**Water Treatment & Transmission Improvements Program  
Draft Environmental Impact Report**

## 2.40 Greg Alioshin

WATER TREATMENT AND TRANSMISSION IMPROVEMENTS PROGRAM  
 LAFAYETTE WTP ALT. 2 - SITE PLAN  
 ATTACHMENT 4

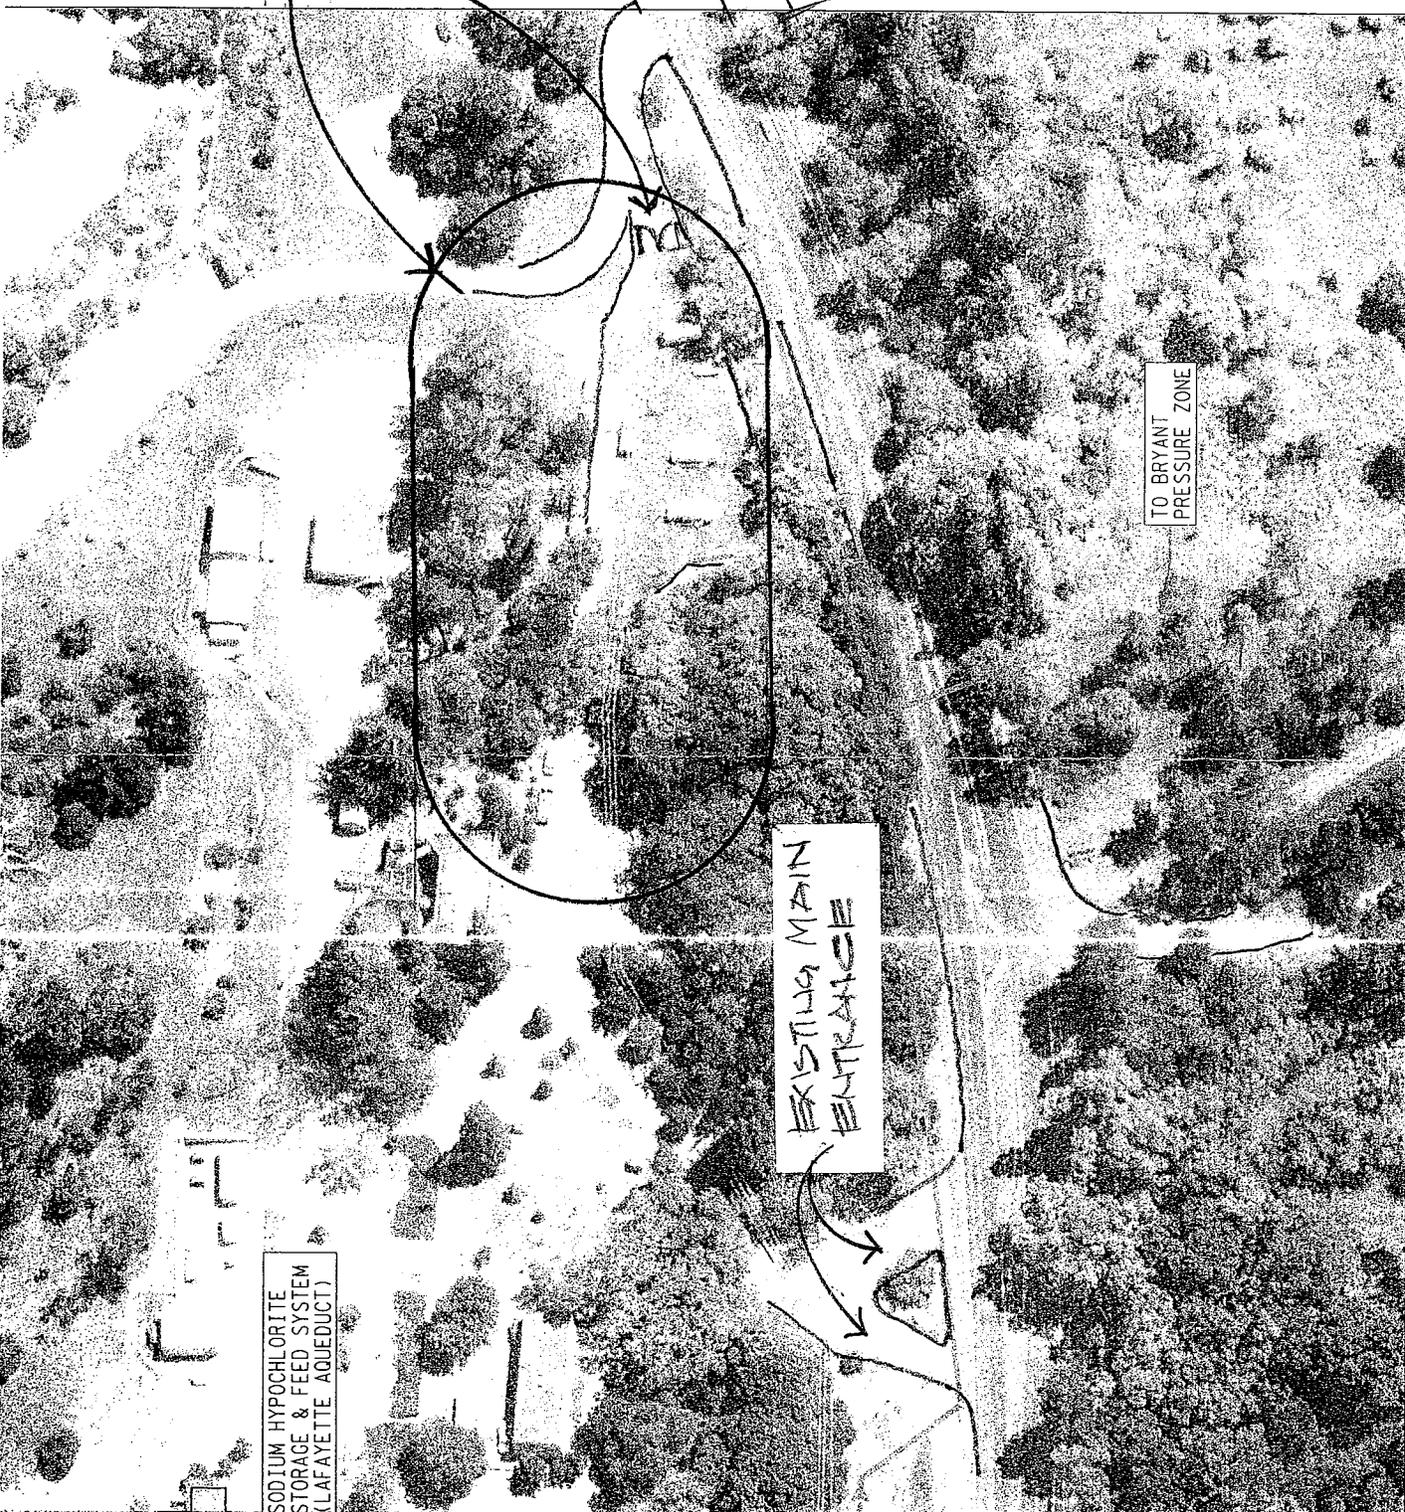
East Bay Municipal Utility District has been a good neighbor except for a few significant exceptions; when the southeast portion of the Lafayette Water Treatment Plant site has been used for receiving, storage, and distribution of materials. This has included the use of large trucks and equipment such as backhoes, which generate loud engine noises and vehicle backup warning alarms. These noises are heard in our homes and are very disturbing during the day, and when it has occurred during the night, sleep has been impossible.

However, if alternate 1 is selected, we request that you include in the Environmental Impact Report noise abatement provisions. These provisions should be for both construction and for the typical use of the southeast portion of the site.

Noise Abatement Provisions should include the following: Truck site access, material receiving, storage, and distribution, both during construction and as typical site use, should be located as far northwest as possible, no closer than the existing main entrance. The existing southeast site, including its entrance, should not be used for these purposes. We request that these provisions be included in the Environmental Impact Report.

The typical current uses of the southeast portion of the site as identified in the site plan attached to your letter are not part of the project under either Alternative 1 or Alternative 2. The mitigation measures within this DEIR do not apply to current, on-going operations in the southeast portion of the site. Please note, however, that your comments have been passed on to EBMUD's Operations department.
